Chapter 14, part 1 – Visual Impact on non-associated residences.

The revised Jupiter SEARs require the developer to:

Here is the Visual Impact rating for residence J241 from LCVIA Appendix A

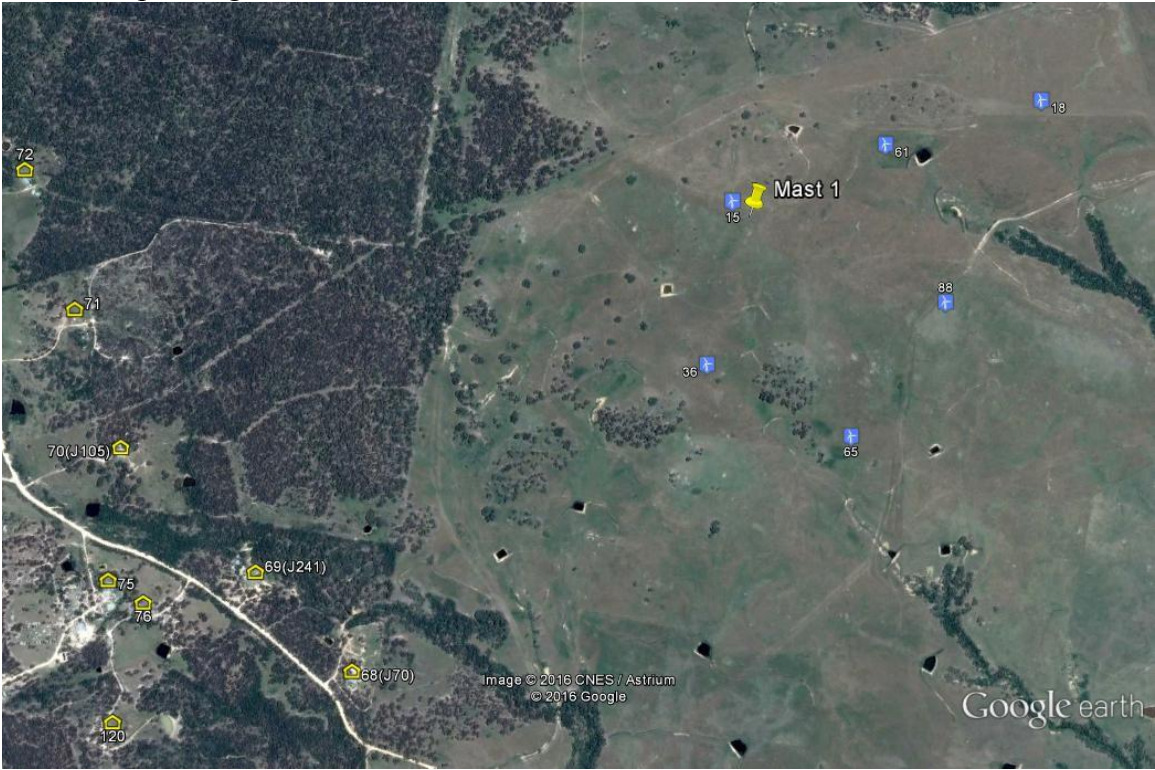
In early January, I drove for the second time ever from Manar to Mulloon. Residence J241 caught my eye. Typical for an area of rural residential character, it is substantial and new.

J241	Dwelling 1 - 2km	739229	6091823	36	1193	NA	Dwelling surrounded by very dense tree planting. No views of WTGs.	Negligible
------	------------------	--------	---------	----	------	----	--	------------

Did any of them notice the wind measurement tower behind the residence? Not just a portion of it but pretty much the whole damn 82 metres of it.

Turbine 15 is next to the measurement tower. So this resident will see, from the curtilage of their residence, virtually the whole of a 173 metre turbine. And we know from Green Bean Design³, one turbine can ruin the view. This resident will see more than one.

The Visual Impact assessment of “negligible” is obviously invalid.

This map below would appear to bear out Clouston’s assessment that “Dwelling is surrounded by very dense tree planting. No views of WTGs”²

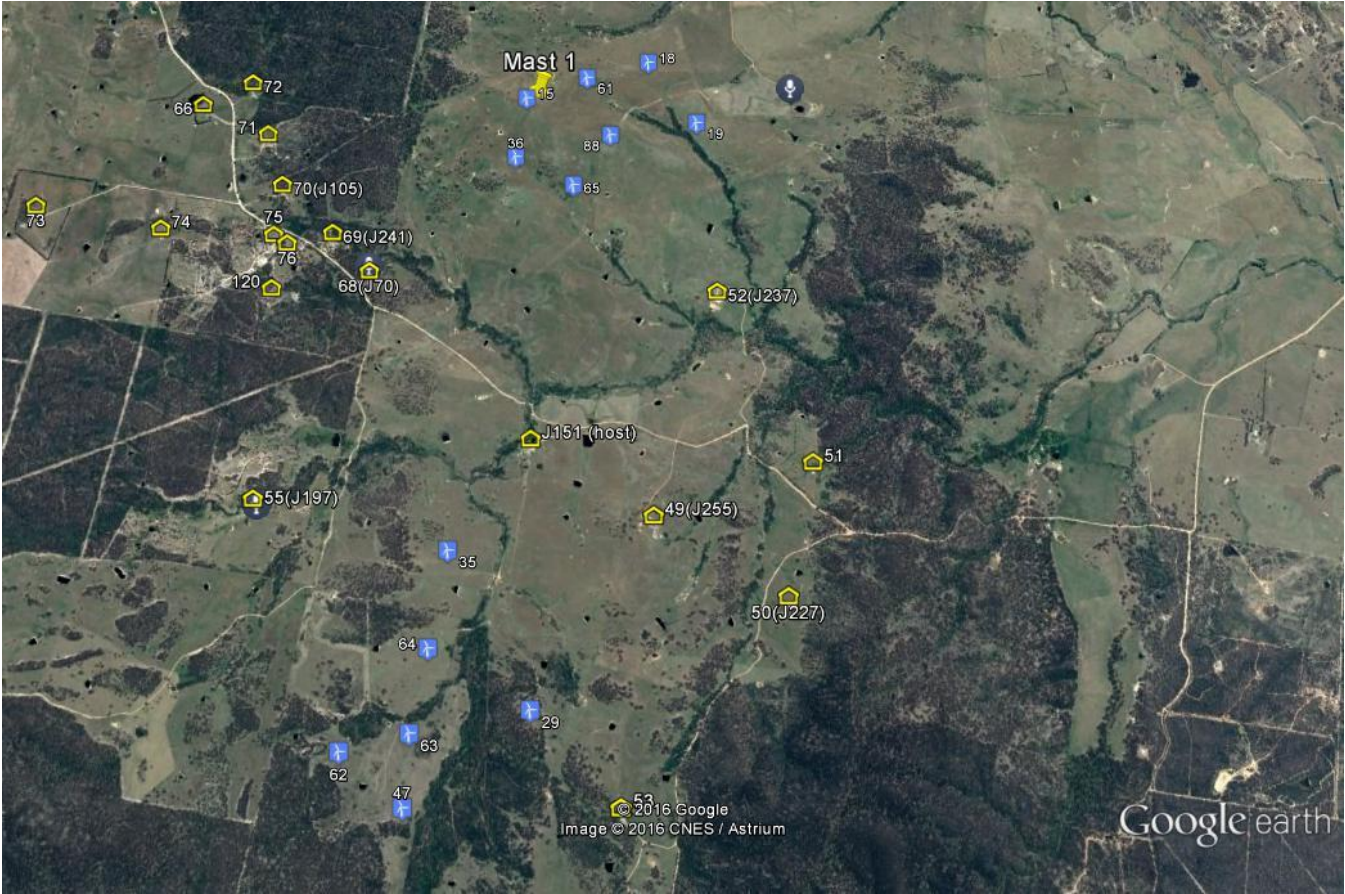
Representatives of Epyc, ERM and Clouston Associates have probably been past this residence more times than I have.
